MiRF - nRF24AP1

TITLE: \${PROJECTNAME}		SFE
Document Number:		REV: V13
Date: \${CURRENT_DATE}		Sheet: \${#}/\${##}
Size: User		Date:
KiCad E.D.A. eeschema 7.0.6		Rev: Id: 1/1

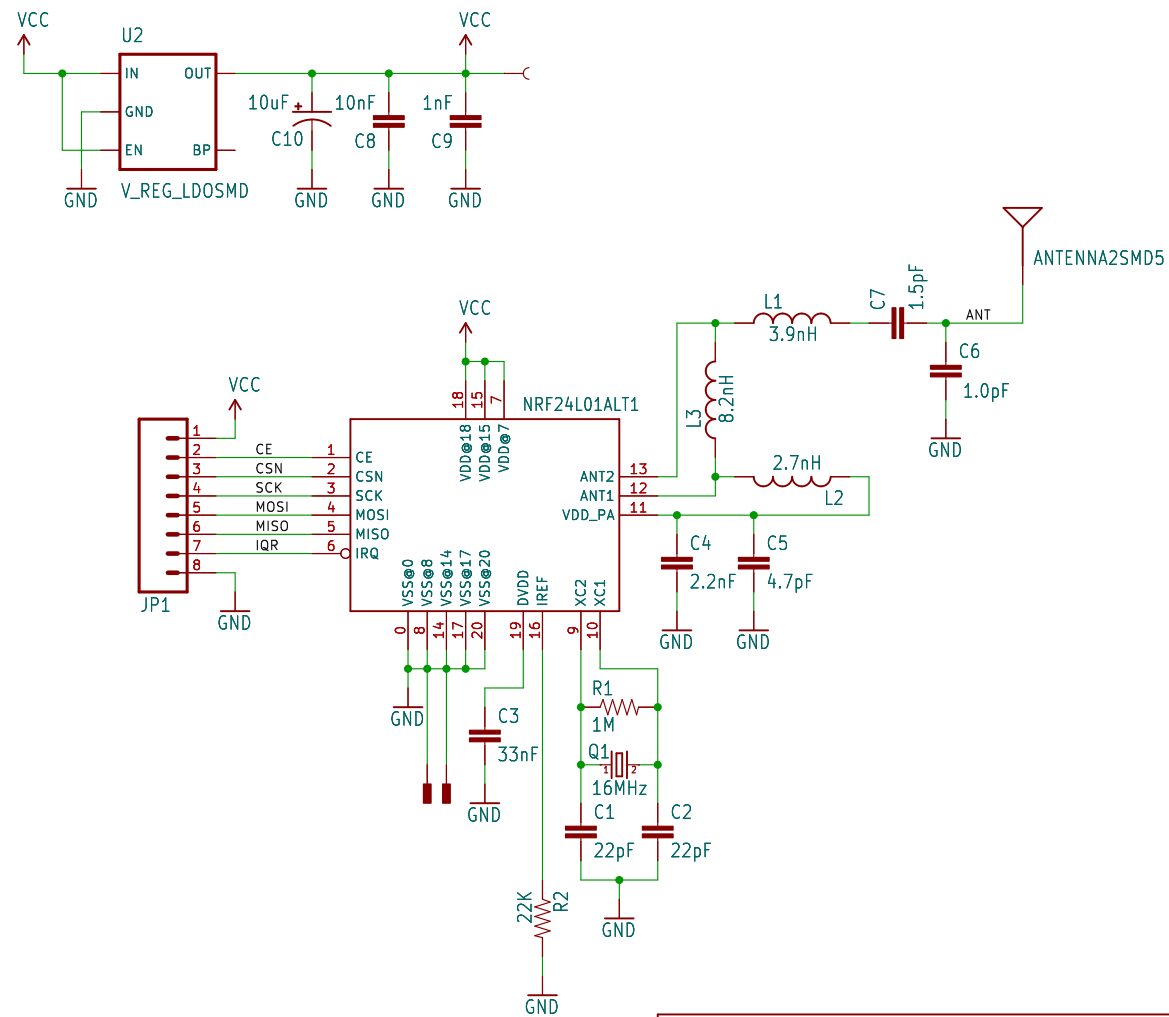
Updates on v13: (1/5/12 Theo)
 -updated annular rings
 -replaced IC footprint with 1:1 rev
 -removed via from under IC
 -routed all traces directly away from IC
 -shifted some parts as necessary
